## EXHIBIT 3 - STAFF REPORT

**DATE:** September 26, 2019  
**TO:** Historic Landmark Committee Members  
**FROM:** Chuck Darnell, Senior Planner  
**SUBJECT:** DDR 4-19 (Downtown Design Review for New Construction including Waiver Requests) – 118 NE 3<sup>rd</sup> Street

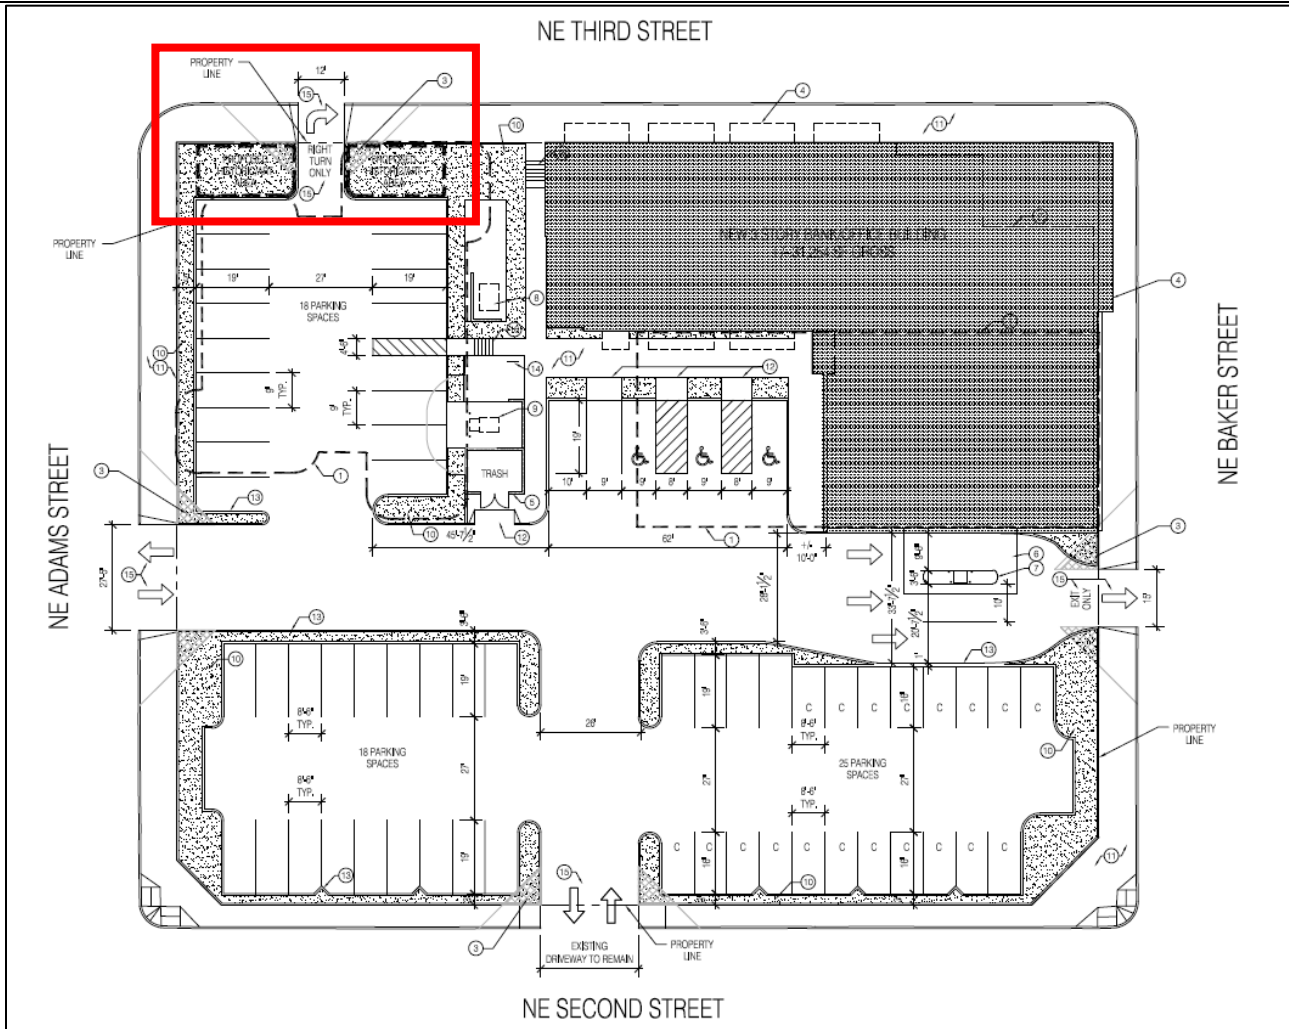
The applicant is requesting two waivers associated with the surface parking lot on the northwest portion of the site, one being that the Downtown Design Standards prohibit parking lots from locating on 3<sup>rd</sup> Street and the other prohibiting access to surface parking lots from 3<sup>rd</sup> Street. The applicant has argued that they have a difficulty in providing of a use for this portion of the site, given their plans for redevelopment and need to keep the existing building operational during construction. Their proposed design to achieve the intent of the Downtown Design Standards chapter is to provide a "Historic/Art Area" between the parking lot and the public right-of-way and sidewalk, to thereby create a type of use between the parking lot and the pedestrian realm. The applicant has described this "Historic/Art Area" as potentially including decorative walls, statues, art, and/or historic district gateway/monument signage.

In terms of access from the parking lot, the applicant has provided arguments for the need for the additional access point due to the unique circumstance of their entire block being surrounded by high classifications of roadways that are often slowed by traffic at the major intersections near the subject site. To address the design of the parking lot access, the applicant is proposing this access point to be only a one-way right-only egress from the surface parking lot onto 3<sup>rd</sup> Street. This reduces the number of vehicles that would use the right-only egress, and allows for the egress drive aisle to be only 12 feet in width to minimize the crossing distance for pedestrians. The "Historic/Art Area" and the right-only egress from the surface parking lot are identified on the site plan below:

If the Historic Landmarks Committee finds that the surface parking lot can be located as proposed and argued for by the applicant, staff has included some suggested conditions of approval related to the “Historic/Art Area” and the right-turn only egress drive aisle. One suggested condition memorializes the collaborative “Historic/Art Area” design process proposed by the applicant, and also memorializes the proposed size and potential features to be included in this area. The second suggested condition of approval provides some additional design parameters for the right-turn only egress drive aisle to minimize conflicts with pedestrians, including that the signage and marking plan be submitted to the Planning Department for review, that the signage not distract from the improvements within the “Historic/Art Area”, and that the surface of the driving area within the “Historic/Art Area” be differentiated from the sidewalk through the use of pavers to better define the pedestrian sidewalk space. There is a recent precedent for a similar level of improvement between the public right-of-way and a surface parking lot in the Downtown Design area. While this example is not a parking lot on 3<sup>rd</sup> Street, it does provide a precedent for the establishment of a use between a parking lot and the sidewalk and the design features included provide for delineation of the space and screening of the parking lot from view.

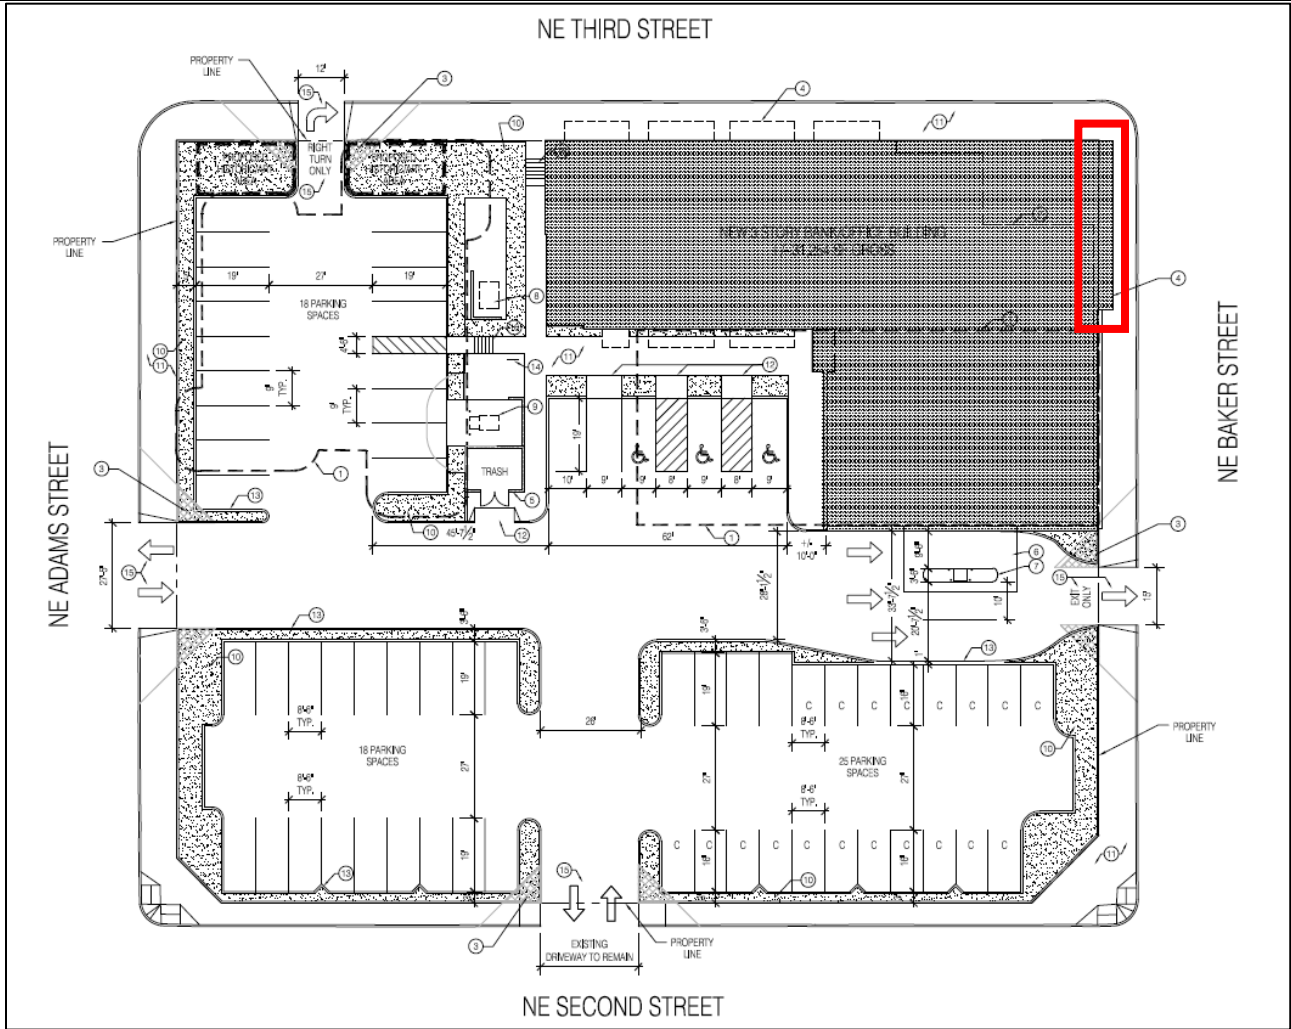
The proposed building design includes a projection of the second and third story into the public right-of-way on the Baker Street (east) façade. The City did request that the applicant send the proposed plans to the Oregon Department of Transportation (ODOT) for review, because Baker Street is part of the Highway 99W system and is under the jurisdiction of ODOT. ODOT did clarify to the applicant that in this section of Highway 99W within the city limits, ODOT only has jurisdiction over uses of the right-of-way between the curbs and that right-of-way use outside of the curbline is subject to City procedures. The McMinnville Engineering Department has reviewed the proposed building design, and because the projection is at a height that provides adequate clearance above the sidewalk, the Engineering Department would allow for the projection into the right-of-way. A condition of approval is suggested to be included to require that the property owner enter into an agreement with the City to allow for the upper story portions of the building to encroach into the right-of-way, if the projection is found to be acceptable to the Historic Landmarks Committee.

This projection is identified on the site plan and the renderings below:

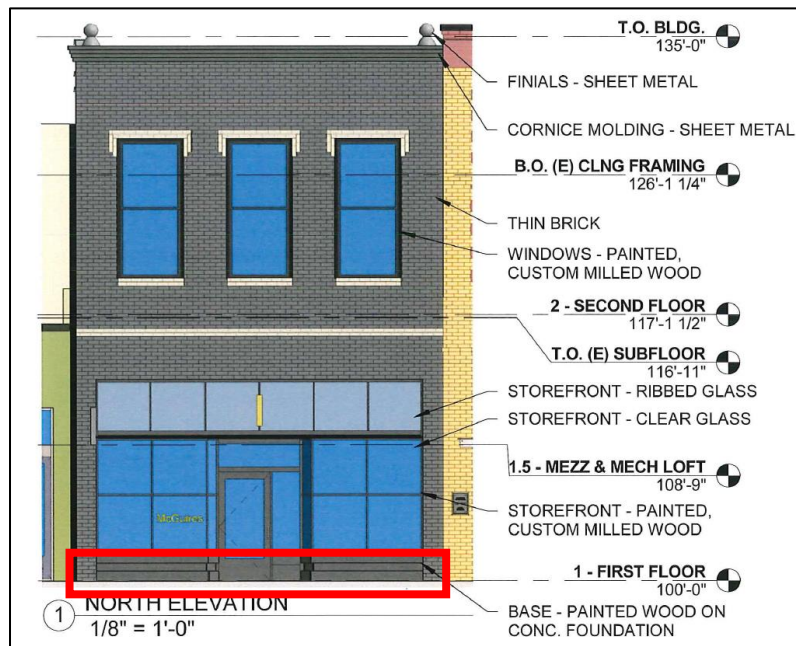
The application narrative describes the foundation or base of the building similarly to the proposed bulkhead, which is provided primarily in areas that have windows along the ground floor façade. However, a true foundation or base is not specifically identified in the elevations and renderings. A more typical type of foundation that has been included on more recent new construction within the Downtown Design area is a continuous concrete foundation immediately above the sidewalk and below the beginning of the primary exterior building material. Examples of this continuous concrete foundation are provided below:

The Historic Landmarks Committee should determine whether the larger foundation proposed by the applicant is acceptable, or whether a smaller foundation similar to the type identified above should be incorporated into the building design. If it is determined that it should be included, staff would suggest that the Historic Landmarks Committee develop a condition of approval to require the smaller concrete foundation to be included in the construction plans submitted for building permit review.

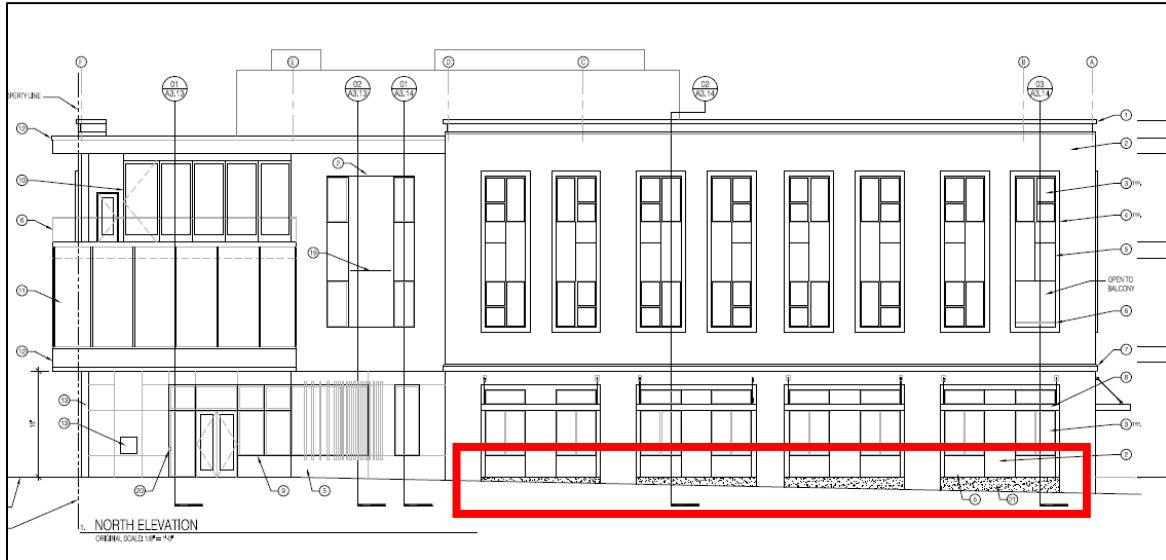
One portion of the façade that is identified differently in the elevation drawings and the renderings is the exposed foundation beneath the windows on the western portion of the 3<sup>rd</sup> Street façade. This portion of the façade is identified in the elevation on Exhibit C9 as “Exposed Foundation Wall, Skim Coat”, but shows up in the renderings as a consistent material beneath the windows to the sidewalk. The applicant has verified that the elevation drawing is correct, and that the exposed foundation wall would be visible in these areas of the façade, and finished with the cement plaster that is similar to smooth stucco. In order to maintain a cohesive finish beneath the windows and for consistency in this area that is described as the bulkhead in other areas of the application narrative, a condition of approval is suggested to be included to require that the skim coated exposed foundation wall be painted a tan color to match the stone panels that will be above. Alternatively, the condition of approval is suggested to also allow for the applicant to install the stone panel over the foundation wall from the bottom of the window all the way to the sidewalk.

This discrepancy between the elevation drawings and the renderings can be seen below:
